This letter is in regard to the Lunken Field Airport Levee shown on the effective Flood Insurance Rate Map (FIRM) and in the effective Flood Insurance Study (FIS) report for Hamilton County, OH. As you may know, the Department of Homeland Security, Federal Emergency Management Agency (FEMA), is in the process of producing a countywide FIS report and Digital Flood Insurance Rate Map (DFIRM) for Hamilton County, OH.

\*The Lunken Field Airport Levee does not meet the requirements set forth in the Code of Federal Regulations, Title 44, Section 65.10 (44 CFR 65.10), which is required for the levee to be accredited as providing base flood protection. Therefore, the levee cannot be shown on the DFIRM as providing protection from the base flood.

## **DE-ACCREDITATION OF LUNKEN AIRPORT LEVEE**

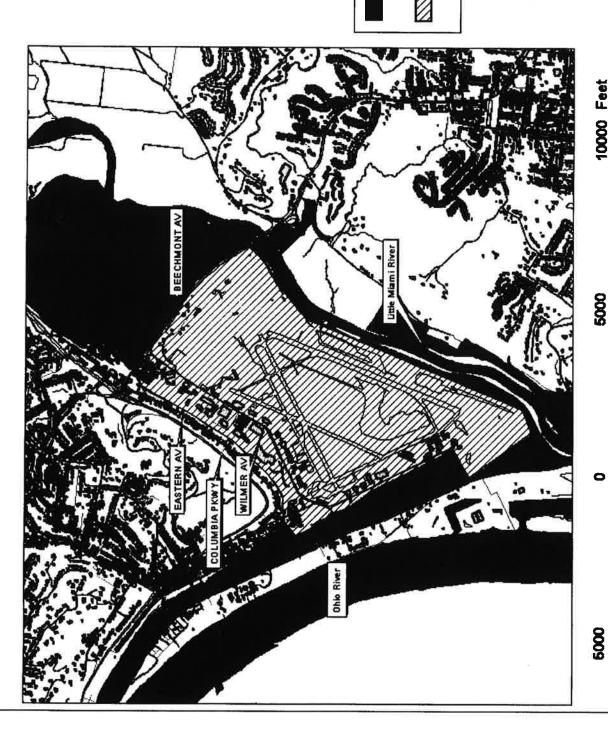
The levee will be de-accredited on the DFIRM. A teleconference was held on August 13, 2007 to inform you of the de-accreditation process. The area landward of the levee will be mapped as Special Flood Hazard Area (SFHA). Therefore, the mandatory flood insurance purchase requirements of the NFIP will apply to these areas when the DFIRM becomes effective. In addition, local floodplain management ordinances must be enforced in these areas. It is highly recommended that you consider this risk in your local emergency management plans, including creating evacuation plans for this area.
